UNITED STATES PATENT AND TRADEMARK OFFICE

APPLICATION NO.	FILING DATE	FIRST NAMED INVENTOR	ATTORNEY DOCKET NO.	CONFIRMATION NO.
10/697,225	10/30/2003	Mary Elizabeth Davis	9396	9781

Office Action Summary	Application No. 10/697,225	Applicant(s) DAVIS ET AL.	
	Examiner Ginger T. Chapman	Art Unit 3761

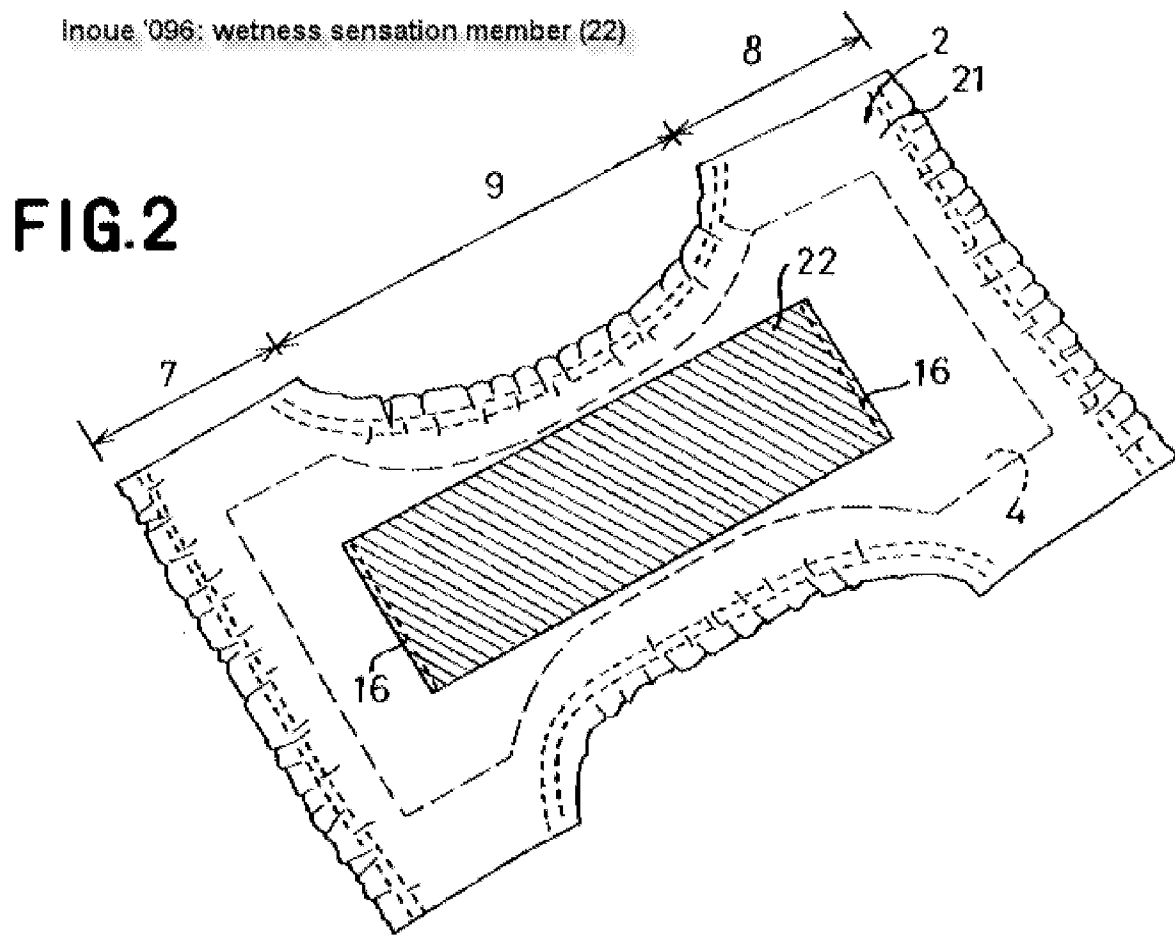
6. As seen in Figures 2 and 3, Inoue teaches a toilet training diaper comprising a wetness sensation member (22, 26) integrated with the topsheet (2). As best depicted in Figures 2 and 3, for purposes of illustration Figure 2 is reproduced below, because the wetness sensation member is a smaller piece of material located on top of the flow control layer (21) and further comprises a different material having different properties and characteristics (c. 2, ll. 30-67 to c. 3, ll.1-10), the examiner has a reasonable basis to conclude that the wetness sensation member (22) would differ in appearance and therefore would be noticeable from its surroundings, *e.g.*, by differing in coloration, hue, or tint, by differing in lightness, darkness, or contrast, by differing due to the presence or absence of solid color forms, or by any other variation serving to create noticeable visible differentiation, and would be substantially unchanged upon wetting. Additionally, Inoue teaches at c. 3, ll. 58-59 that there is a level difference between the layers, *i.e.* the wetness sensation member layer (22, 26) is raised or in relief above the flow control layer (21).

7. Thus the wetness sensation layer of Inoue would appear different in appearance from the remaining portions of the topsheet and thus meets the definition of visible highlighting as set forth by Applicants and therefore fulfills the claim limitations. Therefore, it would have been obvious to one having ordinary skill in the art at the time the invention was made to form the

wetness sensation member of Iguae differing in appearance from the other portions of the topsheet, i.e. visibly highlighted, as taught by Inoue in order to provide a visibly noticeable wetness sensation member for toilet training since as long as the member is visible when being viewed, its visibility indicates its presence.
